FEDERAL ENERGY REGULATORY COMMISSION

**Atlantic Coast Pipeline, LLC
Dominion Transmission, Inc.**

**Docket Nos. CP15-554-000
CP15-554-001
CP15-555-000**

**COMMENTS OF
SHENANDOAH VALLEY NETWORK,
HIGHLANDERS FOR RESPONSIBLE DEVELOPMENT,
VIRGINIA WILDERNESS COMMITTEE,
SHENANDOAH VALLEY BATTLEFIELDS FOUNDATION,
NATURAL RESOURCES DEFENSE COUNCIL,
CONCERNED CITIZENS OF TILLERY,
COWPASTURE RIVER PRESERVATION ASSOCIATION,
DEFENDERS OF WILDLIFE,
DOMINION PIPELINE MONITORING COALITION,
FRIENDS OF BUCKINGHAM,
JACKSON RIVER PRESERVATION ASSOCIATION,
JAMES RIVER ASSOCIATION
NATIONAL PARKS CONSERVATION ASSOCIATION,
PIEDMONT ENVIRONMENTAL COUNCIL,
POTOMAC RIVERKEEPER NETWORK,
ROCKBRIDGE AREA CONSERVATION COUNCIL,
SHENANDOAH RIVERKEEPER,
SOUND RIVERS,
WATERKEEPERS CHESAPEAKE,
THE WILDERNESS SOCIETY, AND
WINYAH RIVERS FOUNDATION
ON THE
DRAFT ENVIRONMENTAL IMPACT STATEMENT FOR THE
PROPOSED ATLANTIC COAST PIPELINE AND SUPPLY HEADER
PROJECT**

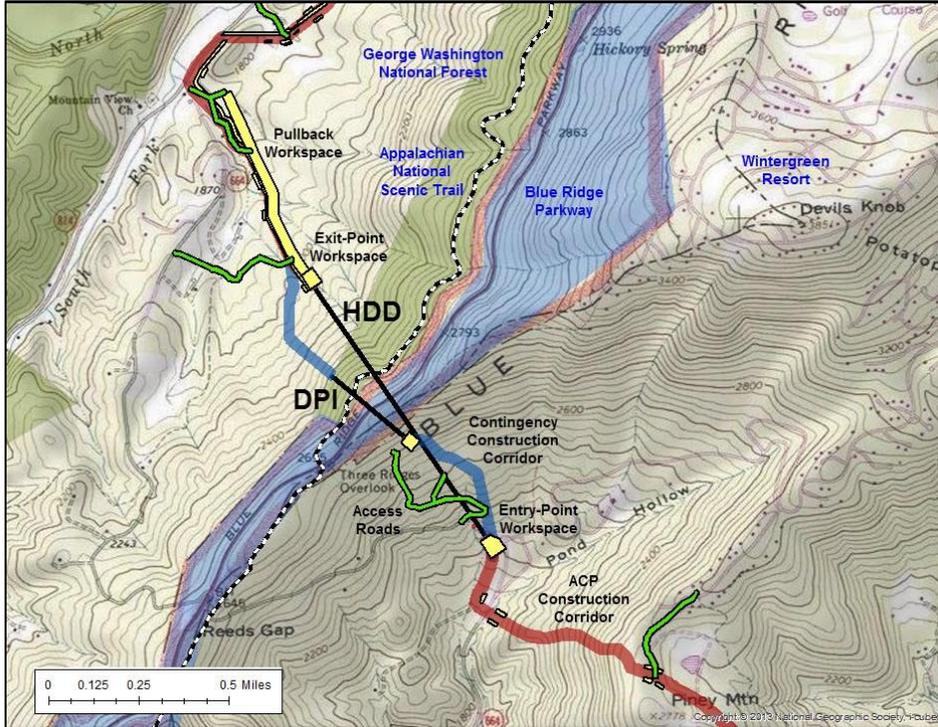
The HDD operation would involve drilling for 4,639 feet at 800 feet below the crest of the Blue Ridge.⁴⁸⁶ The contingency DPI operation would involve drilling for 1,396 feet at 200 feet below the crest.⁴⁸⁷ Both methods are commonly used for installing pipelines under rivers or other obstacles where the terrain is relatively flat and extremely hard or fractured bedrock is not encountered. The use of either method to drill for long distances through steep mountains is less common. Atlantic’s proposal for drilling through the Blue Ridge approaches the limits of

As described in this section, both the HDD and DPI methods involve substantial risks of failure and environmental damage, given workspace limitations

FIGURE VII(e) – Extreme pullback required for the proposed Blue Ridge HDD.

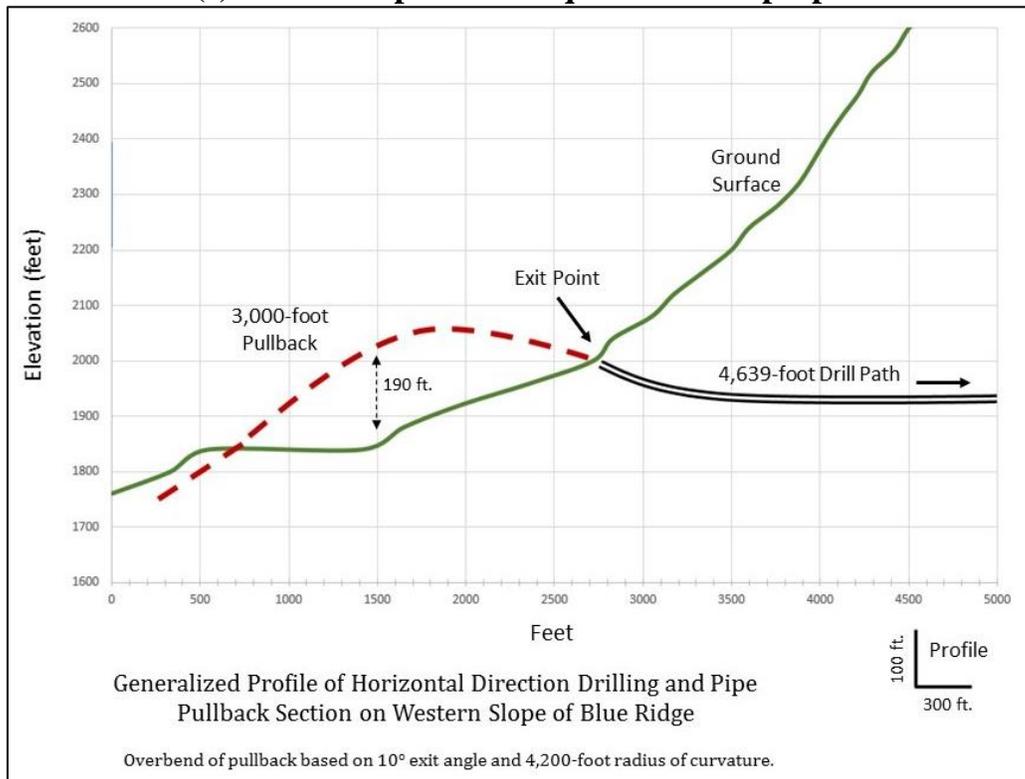
inch steel pipe is 4,200 feet.⁴⁹⁷ Given this bending radius and the slope of the location, it will be necessary to suspend the pipe for approximately 2,000 feet at heights approaching 200 feet above the mountainside (see **Figure VII(e)**). If this is even practicable, it will require significant excavation for access, pipe fabrication and testing, and siting of the multiple large cranes or other heavy equipment needed for pipe handling and support. The required suspension of pull-section pipe for the proposed mountainside HDD operation greatly exceeds what is required for typical HDD operations on relatively flat ground. For example, see **Figure VII(f)**.

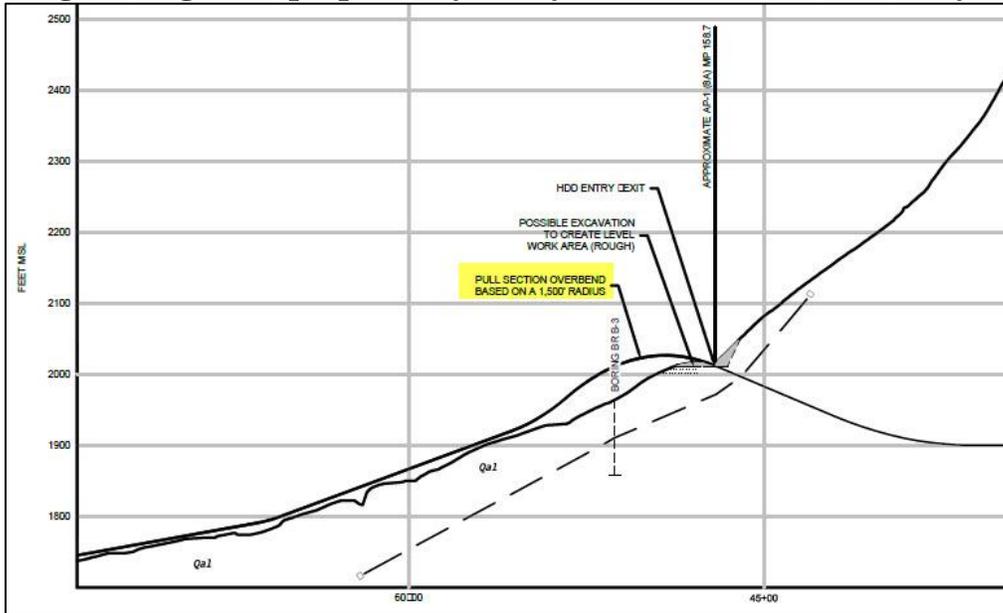
The contingency DPI installation, which would occur on even steeper slopes than the proposed HDD operation, also raises questions about the potential footprint of the staging and fabrication area and the need for pipe suspension.⁴⁹⁸ The fact that the suspension of pullback pipe and the magnitude of the related footprint were not addressed in the draft EIS may be due to incorrect or misleading information provided to the Commission by Atlantic. The only depiction of the HDD pullback section included in Atlantic submissions to the Commission is based on a 1,500-foot bending radius (see **Figure VII(g)**).

This differs substantially from the correct 4,200-foot bending radius. As indicated in the depiction, a shorter bending radius would require much less lifting of the pipe. The necessary elevation would only be about 50 feet compared to about 200 feet for the longer correct bending radius. The length of pipe suspension would also be much less.

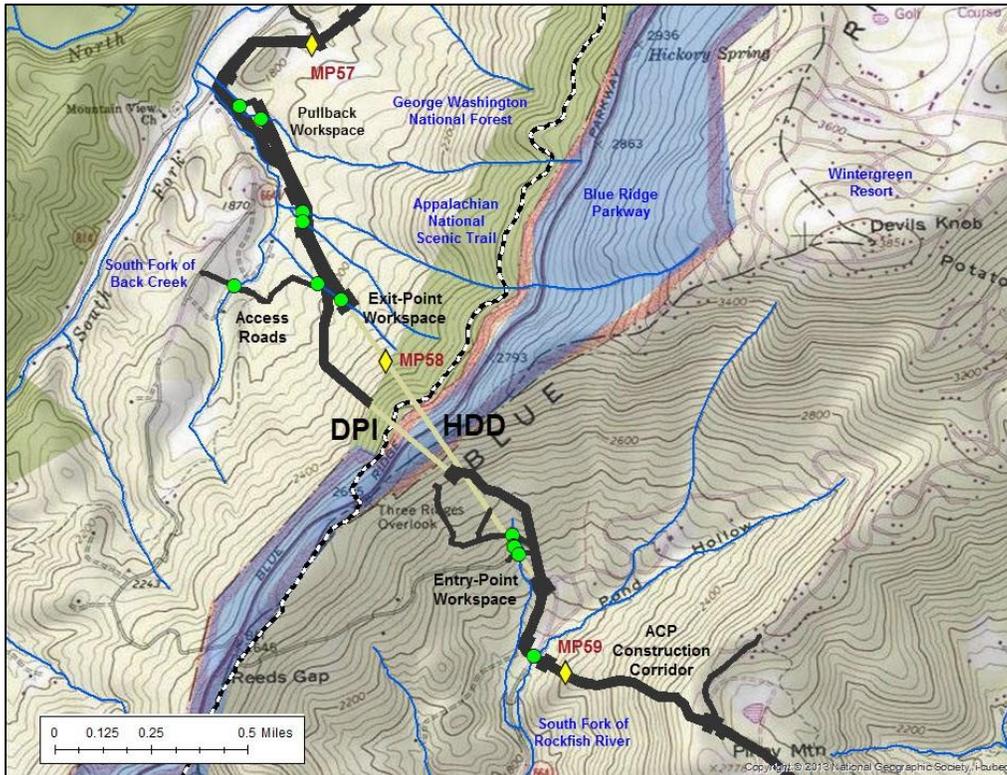
FIGURE VII(h) – Streams crossed by construction associated with the proposed HDD and contingency DPI operations. The green symbols indicate stream crossings by the pipeline construction corridor, entry- and exit-point workspaces, pipe pullback and other workspace, and access roads. The yellow symbols indicate ACP mileposts. The stream lines shown on the map were obtained from the National Hydrography Dataset (U.S. Geological Survey). Note that more stream crossings are listed for this area in the draft EIS (see Table VII(a)). The reason for the difference has not been determined.

FIGURE VII(i) – Recommended exit-side and pullback pipe fabrication workspace.

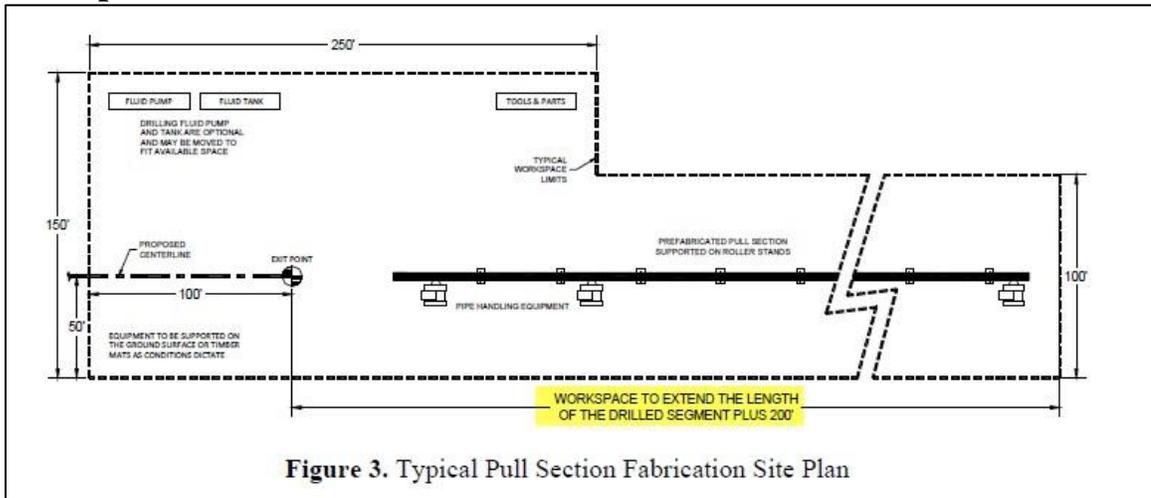
The length of the drilled segment for Atlantic’s proposed HDD is 4,639 feet. The recommended pullback segment would thus be 4,839 feet. However, as indicated in the draft EIS, the length of the workspace available for staging the pipe pullback is only about 3,000 feet, which makes fabrication, hydrostatic testing, and pullback of the recommended single continuous pipe string impossible.

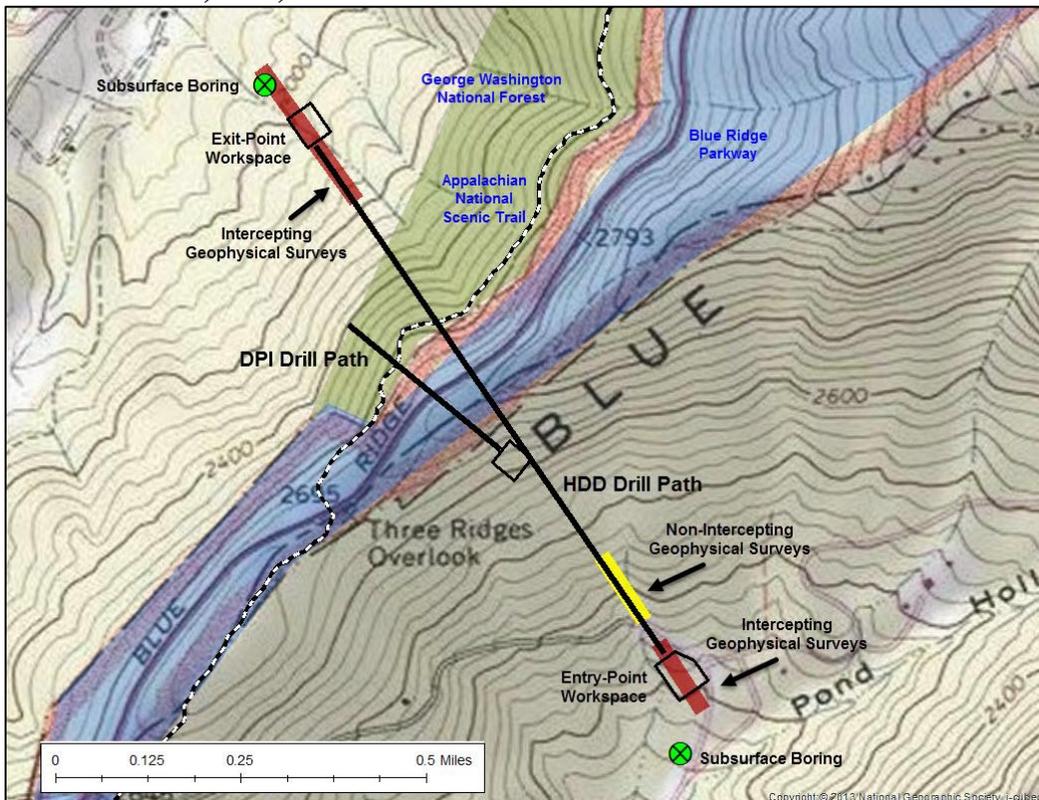
the two subsurface borings and other geophysical surveys for the HDD are indicated in **Figure VII(k)**.

Neither the borings nor the geophysical surveys were focused on the full length of the proposed drill path, and none of the information obtained through borings or geophysical surveys confirms “that the drill path would be primarily through solid

FIGURE VII(1) – Interpreted results of geophysical surveys conducted at the entry- and exit-sides of the proposed HDD drill path. (Based on Geophysical Study for a Proposed Blue Ridge HDD Crossing Augusta and Nelson Counties, Virginia, prepared by ATS International, Inc., 4/12/16.)

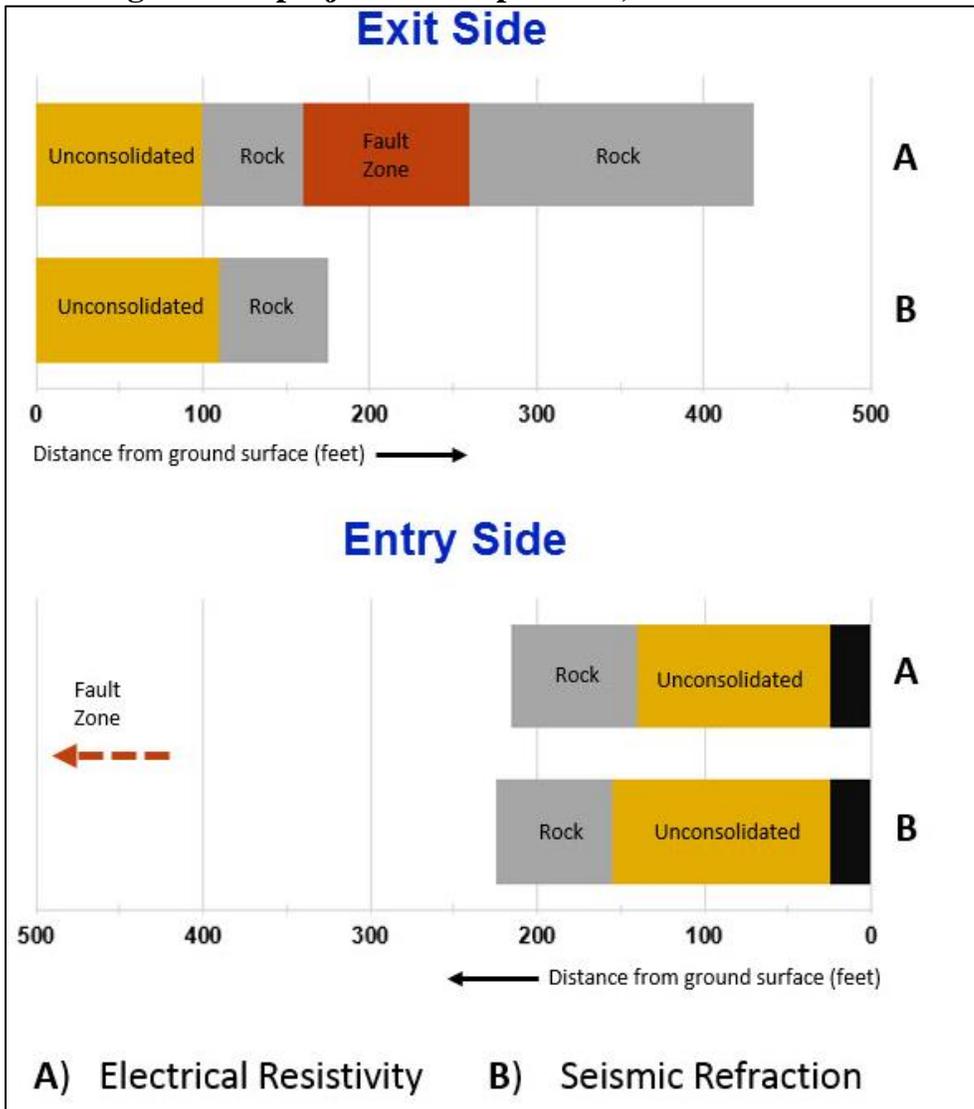
Results are shown for survey sections where imaging intercepted the projected drilling path. The fault zone in the entry-side section was estimated based on non-intercepting surveys, and was estimated to begin at 425-550 feet from the ground surface. The black-colored segments starting at the ground surface on the entry side indicate planned excavation. The total length of the projected drill path is 4,639 feet.

In fact, the geophysical services company that conducted and interpreted the surveys raised questions concerning the reliability of even its limited findings,
